IOWA DEPARTMENT OF AGRICULTURE & LAND STEWARDSHIP

To:	All plan holders	From:	Tracy Blocker, Division
Pages:		Phone:	515-344-6279
Re:	Cer962218CNutrient Reduction Wetland (Bid #26-05)	Date:	July 12, 2026

Subject: **Addendum No. 1** to Bid Documents
CER962218C Nutrient Reduction Wetland Project – Bid No. 26-06
Cerro Gordo County, Iowa

Project Description and Location: Cer962218C Nutrient Reduction Wetland Project
Section 18, Township 96 North, Range 22
West Cerro Gordo County, Iowa

NEW PLAN B.02

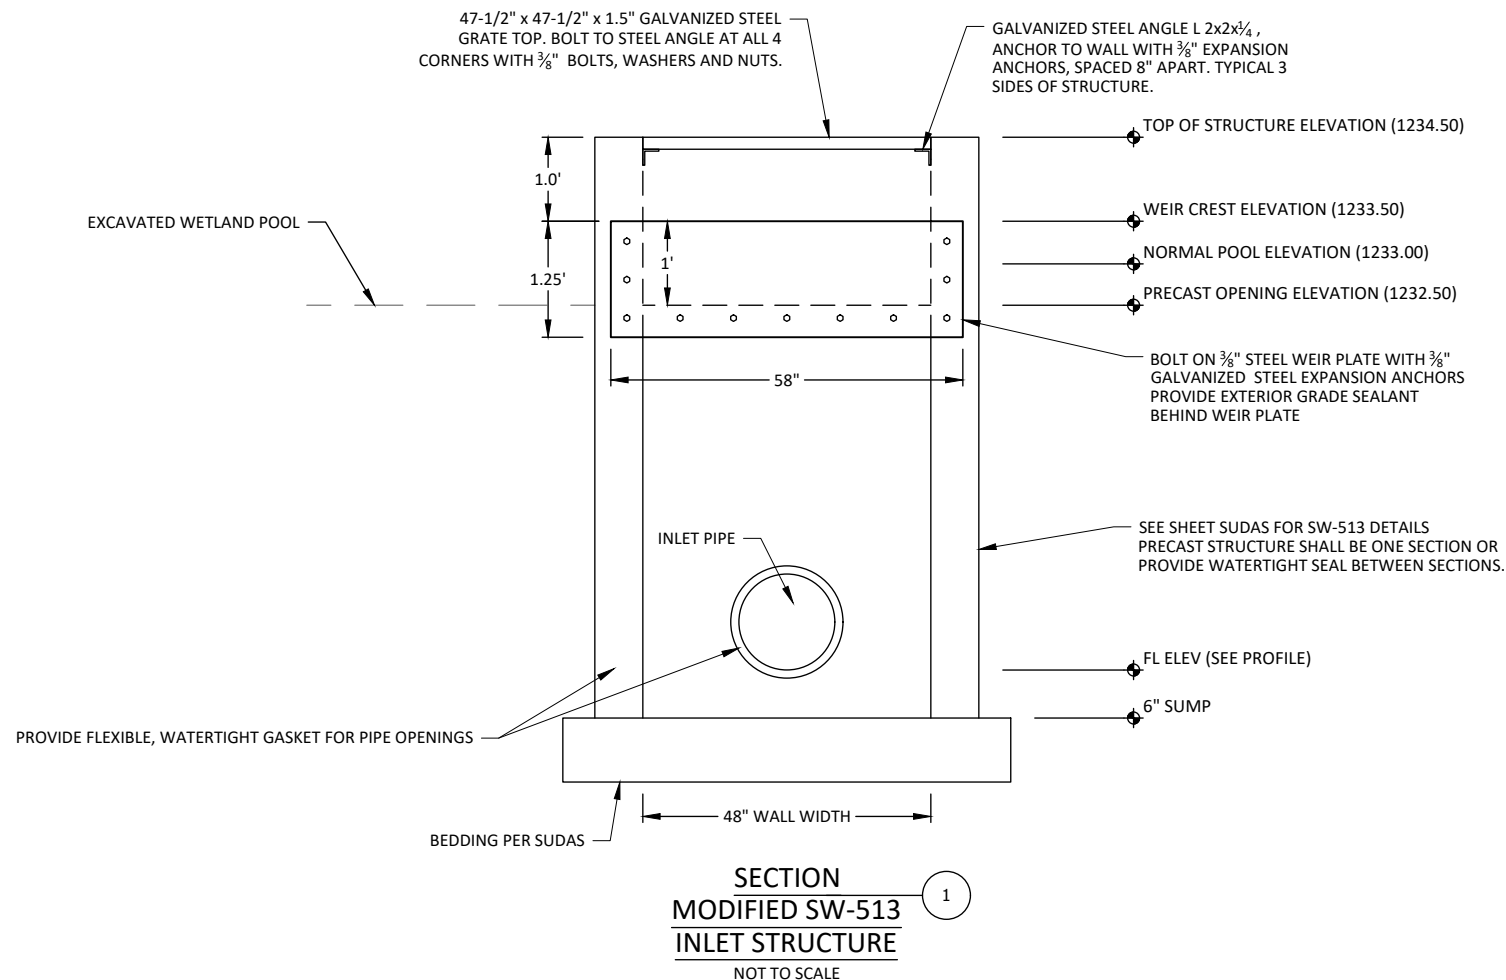
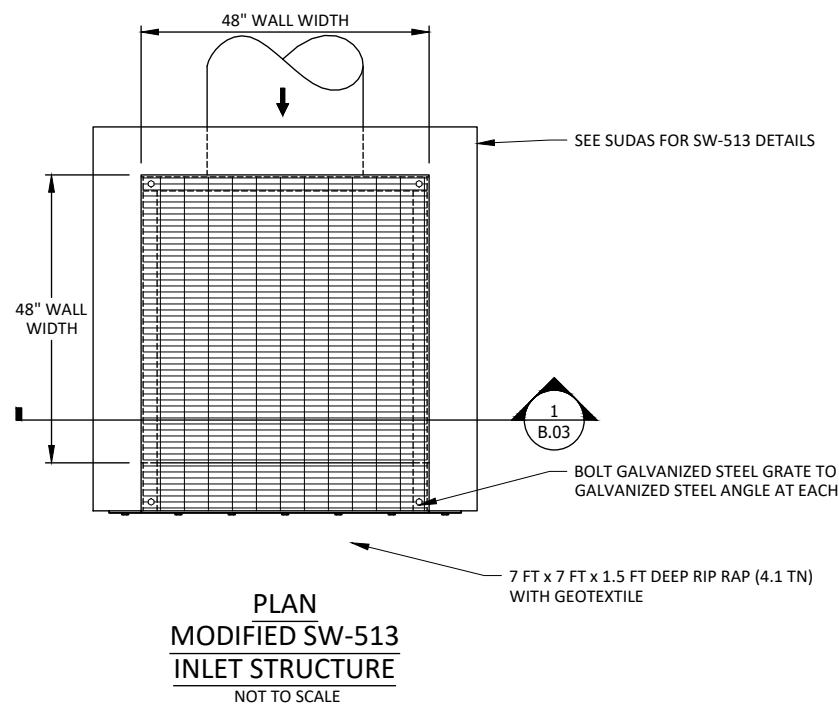
- New Plan B.03 is being added to the engineering plans set, to include the design and construction details of Bid Item #12 “Modified SW-513 Inlet”.

- i. New Plan Sheet B.03 is being added to the plan set, with the detail for the Modified SW-513 Inlet Structure, Bid Item # 12.
- ii. Specifications CS-008, will replace the installation detail for a 48" x 48" sign with the installation detail of a 72" x 120" sign.

1. BAR GRATE SHALL BE McNICHOLS HEAVY DUTY WELDED GHB-100, 19 W-4, OR APPROVED EQUAL.
2. ALL FASTENERS SHALL BE GALVANIZED OR STAINLESS STEEL.
3. WEIR PLATE, STEEL GRATE, AND ALL HARDWARE AND APPURTENANCES SHOWN ON THIS PAGE OR REQUIRED FOR INSTALLATION ARE SUBSIDIARY TO THE INLET STRUCTURE.

CS 008, Large sign installation details

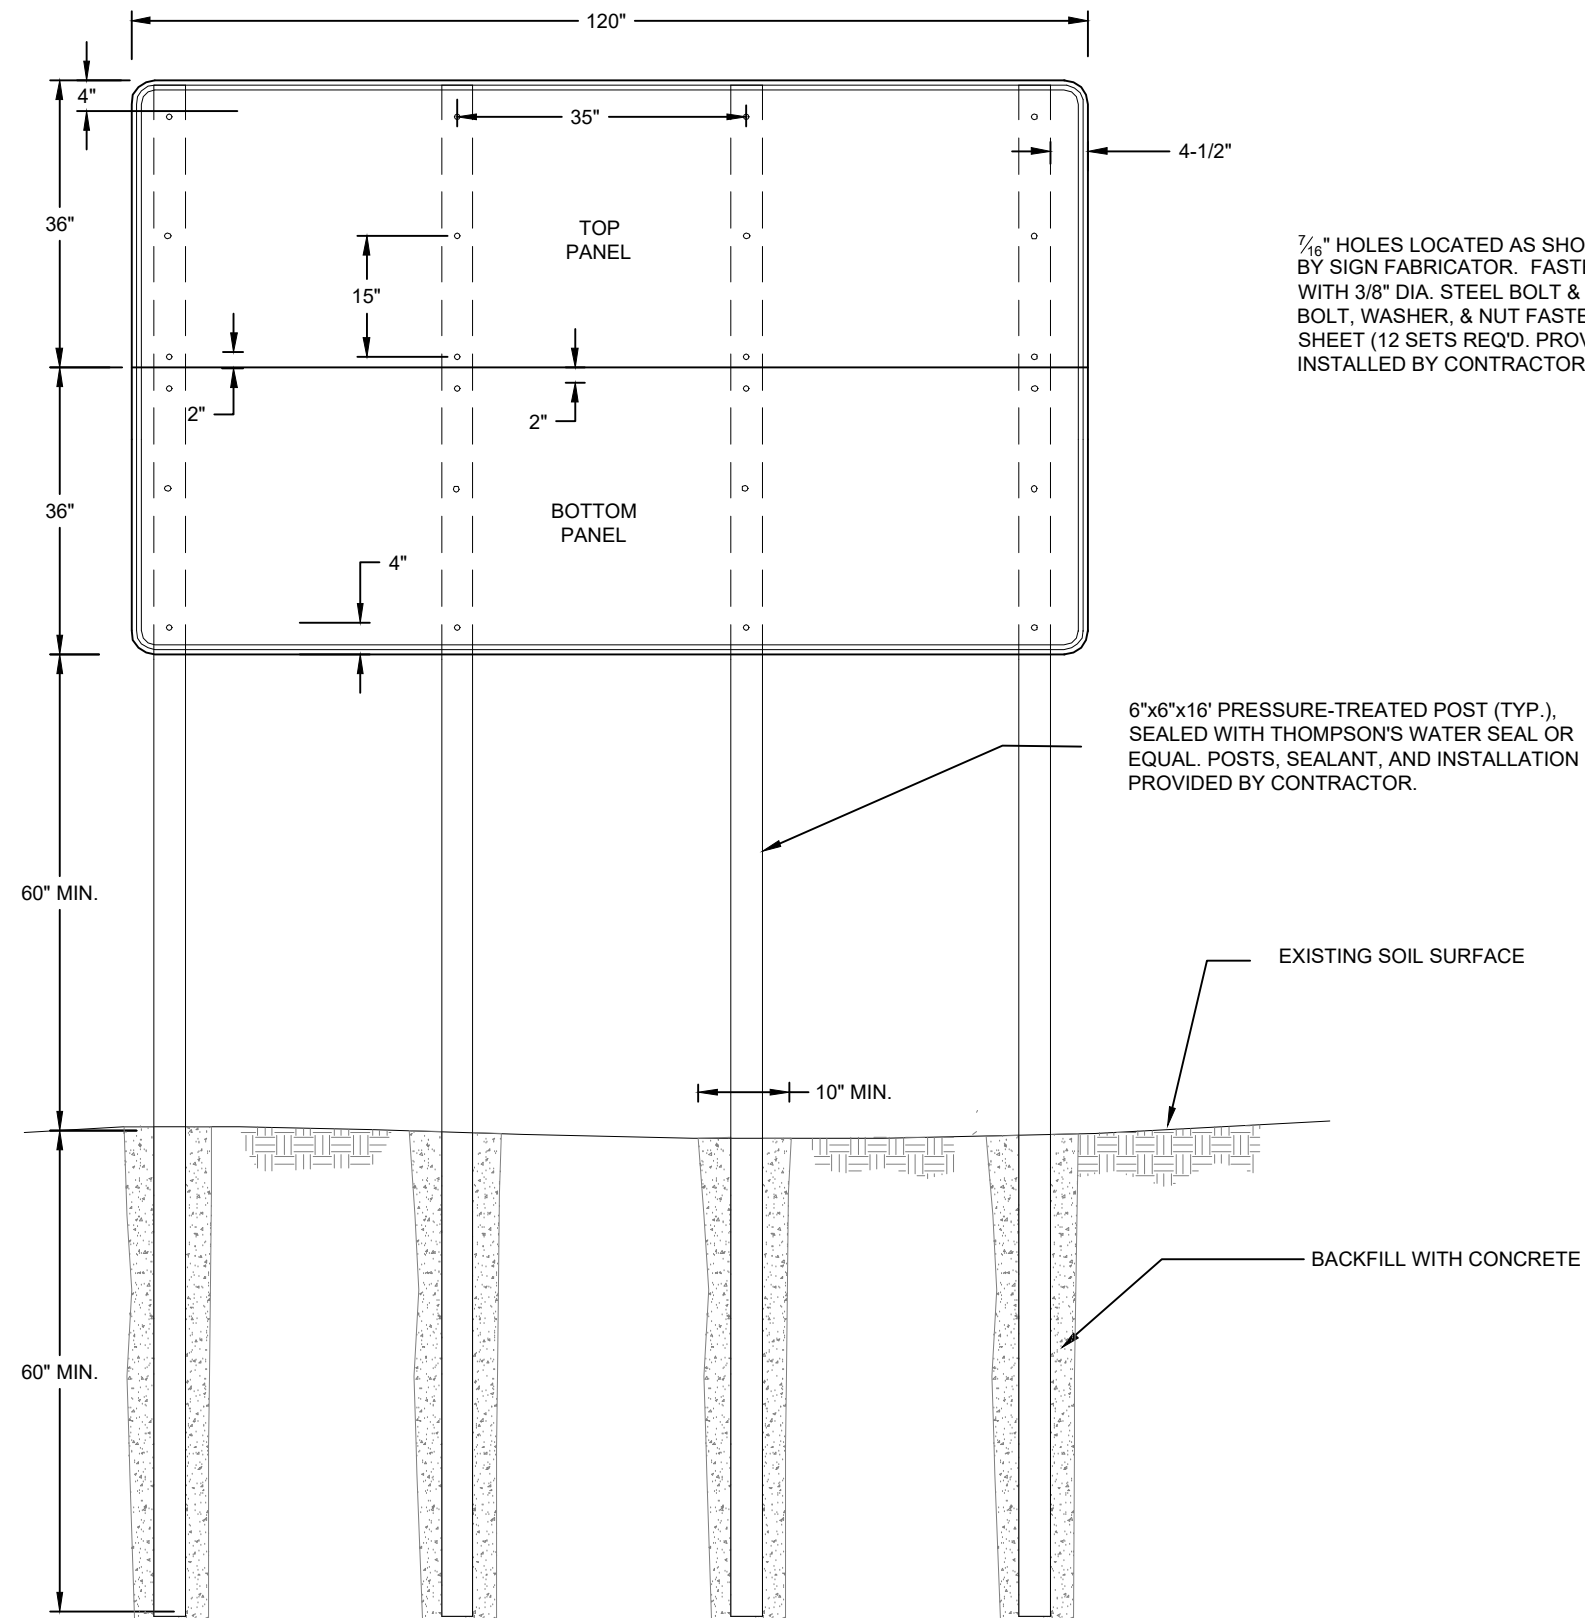
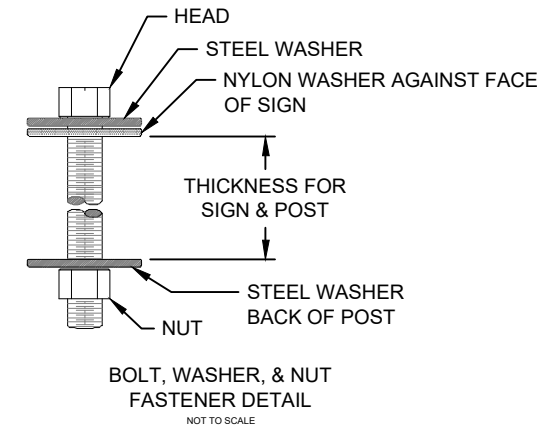
- Specifications CS 008 “Mobilization and Demobilization” has been modified to replace the installation details of a 48” x 48” sign with the installation details of a 72” x 120” sign. IDALS will provide the sign only.

7/16" HOLES LOCATED AS SHOWN, PRE-PUNCHED BY SIGN FABRICATOR. FASTEN SIGN TO POSTS WITH 3/8" DIA. STEEL BOLT & NUT SET, SEE BOLT, WASHER, & NUT FASTENER DETAIL THIS SHEET (12 SETS REQ'D. PROVIDED AND INSTALLED BY CONTRACTOR).

1. DIVISION WILL FURNISH SIGN PANELS. CONTRACTOR IS RESPONSIBLE FOR PROVIDING POSTS, HARDWARE, AND INSTALLATION FOR ALL PANELS.
2. ALL EXPOSED WOOD SHALL BE SEALED WITH THOMPSON'S WATER SEAL OR EQUAL MEETING ASTM D-4446-08.
